# Service Information

HD4500 HD4501  
HD4502 HD4503

DAP128

Reference is made to Service Manual 4822 729 21635

IEC version only :

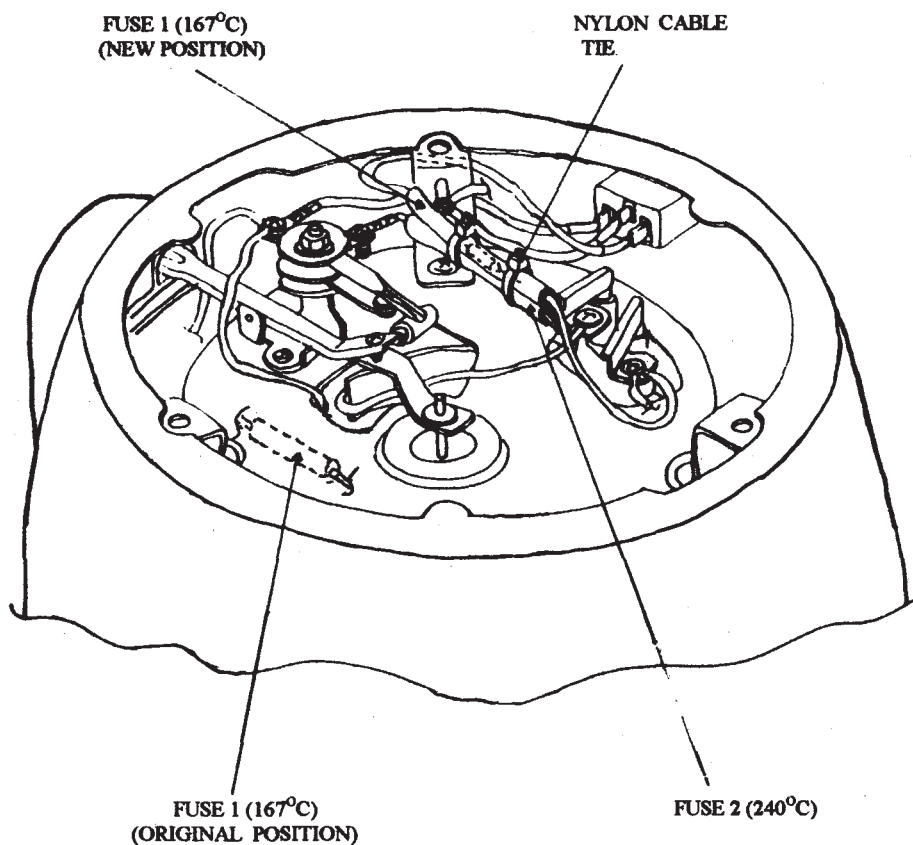
If in these version thermal fuse 1 ( Item 13, attached to the bottom ) need replacement, fix a new fuse above fuse 2 and tie with Nylon cables. Do not fix it to the original position.
